ADDENDUM NO. 2

DATE: August 26, 2015

12-C-00058; Channel District: 12th Street Wastewater Pump Station Improvements

2014 Aerials

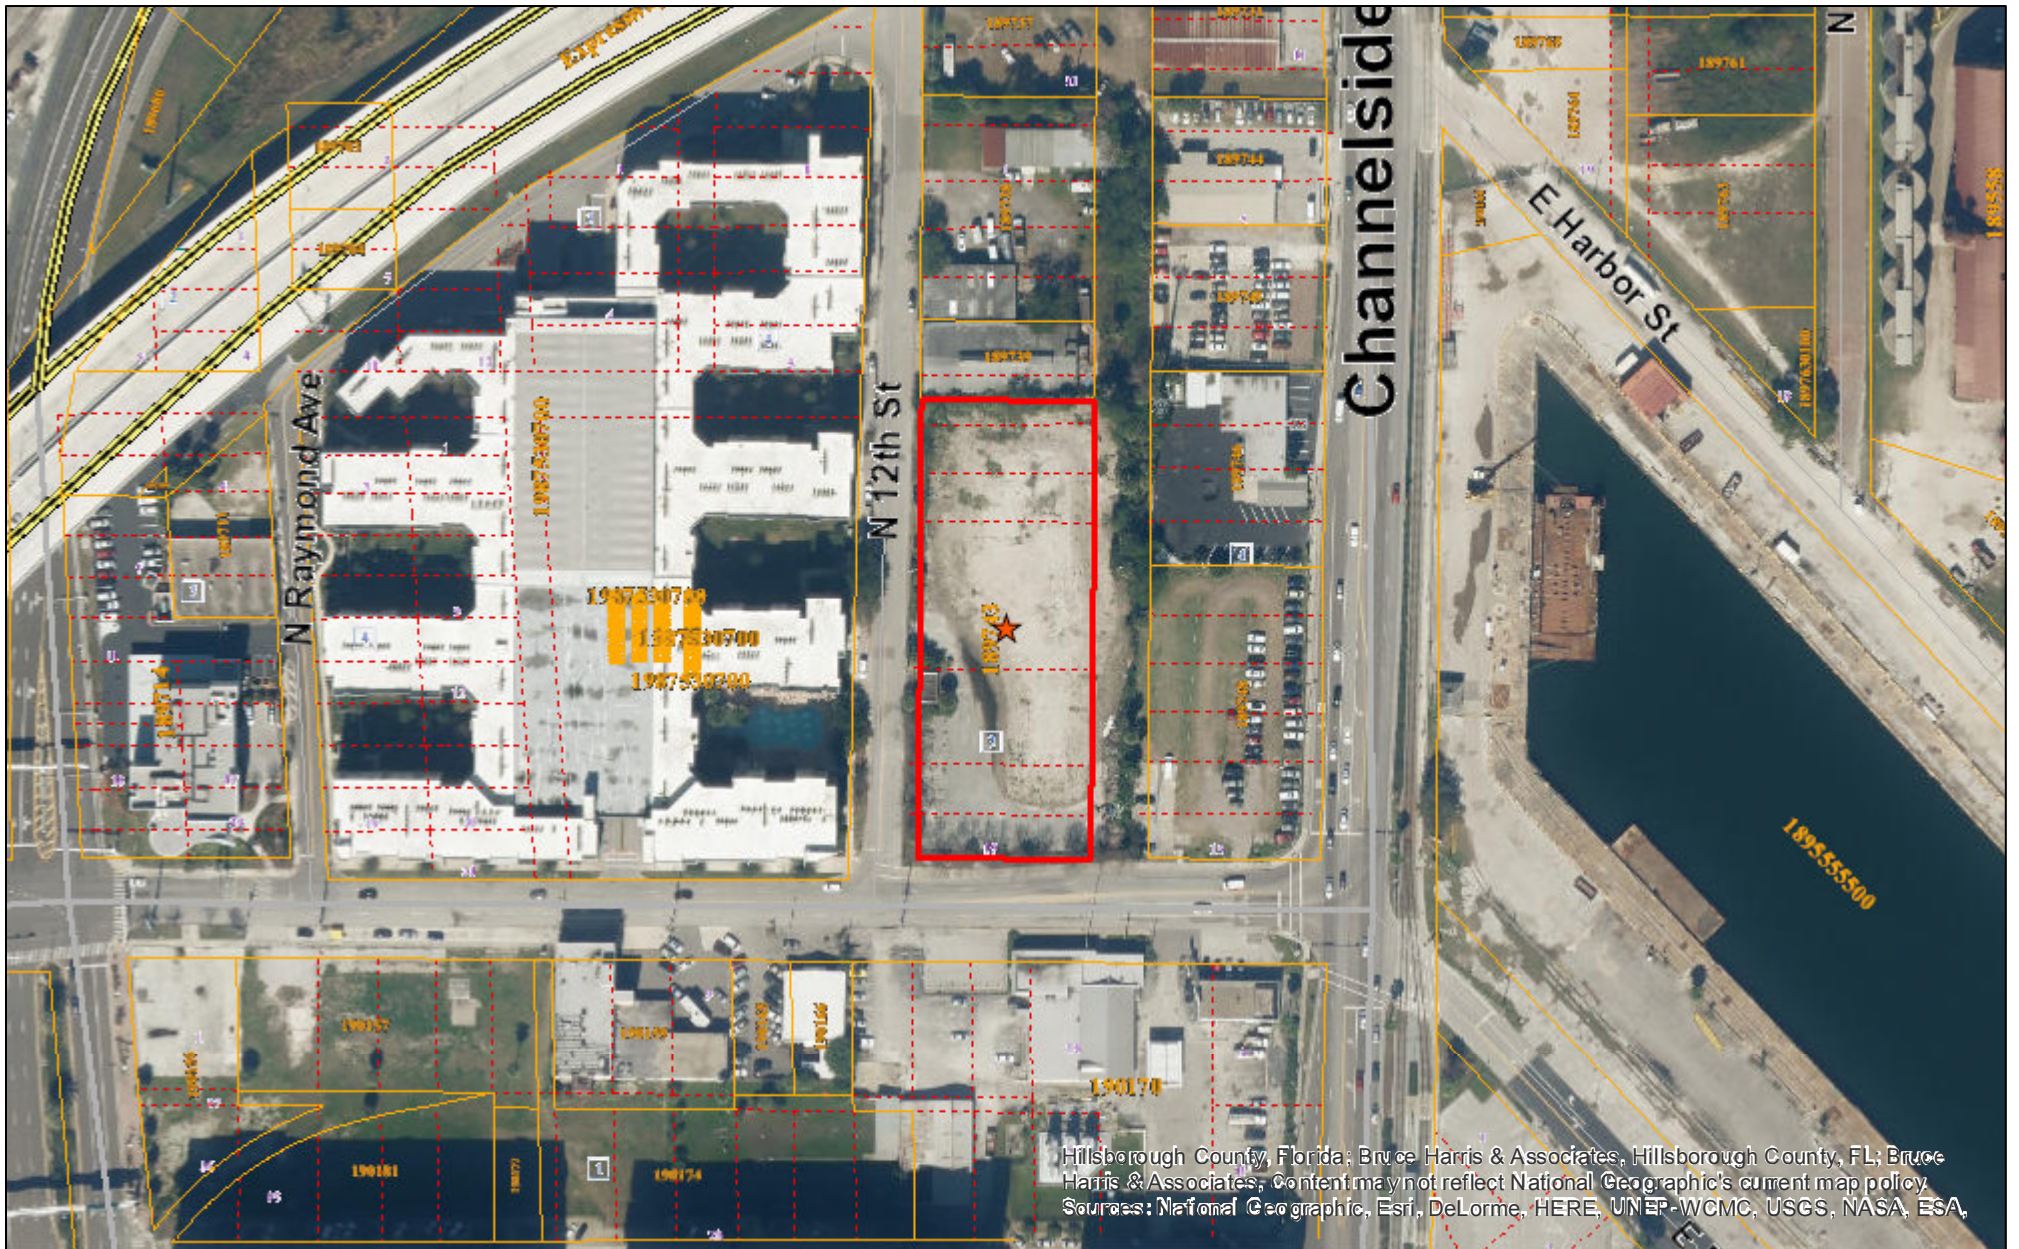
Item 10: Question: Will the Contractor be allowed to use the surrounding open lot for storage and construction activities? If not, then what will be the work area constraints?

Response (provided by City/CAD-P&D): Following award of the Construction Contract, the City will obtain a Temporary Construction Easement to allow the Contractor to use the surrounding property for construction related activities (reference attached aerial which shows general configuration of subject property within red lined rectangle). As a Contract requirement, all areas disturbed by construction activities shall be restored to be equal to or better than the pre-construction conditions.
